WHAT WE HEARD

In January 2022 ACHD reached out to the public to gather feedback on the design. Below is a summary of the feedback that we received.

The following are general themes received with support and concern of the proposed roundabout design at the Ten Mile and Lake Hazel intersection.

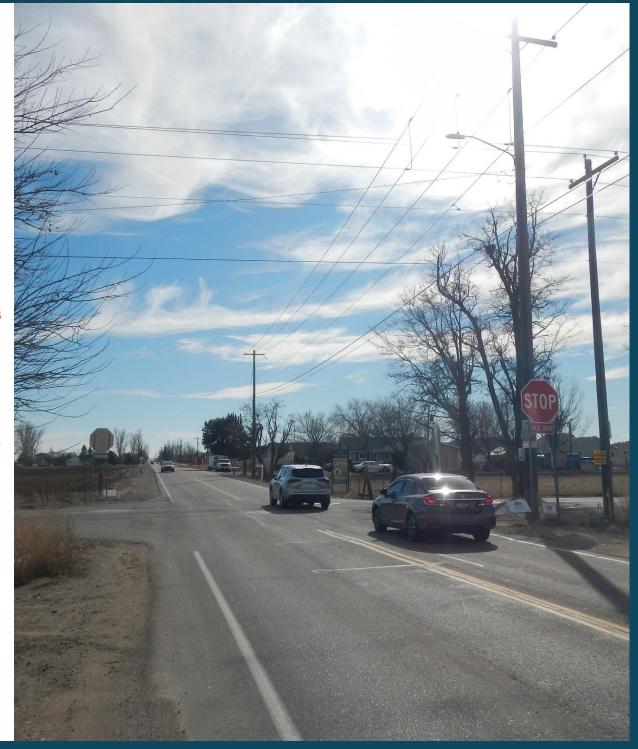
- Q. The lanes on the Ten Mile Road and Amity Road roundabout seem tight. Is it possible to make the Ten Mile Road and Lake Hazel Road Roundabout a bit wider?
- A. The design vehicle for the roundabout is a standard interstate semi-truck (WB-67), and the lanes are widened appropriately for the large-vehicle to perform all turning movements. A truck apron around the center of the roundabout allows semi-truck trailers to offtrack onto the apron.

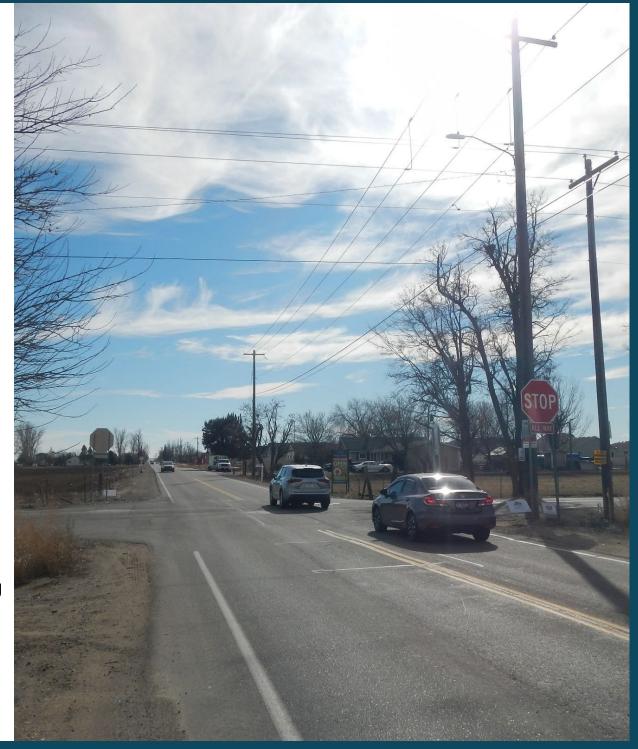
- Q. With growth in the valley, we are seeing recent construction needing to be rebuilt soon after to accommodate growth. Is it better to spend extra now to save later?
- A. This is the goal of the intersection improvement. The roundabout is a phased dual-lane roundabout which allows for expansion to a dual-lane (two circulating travel lanes) roundabout when needed in the future by simply adjusting median islands and signing.
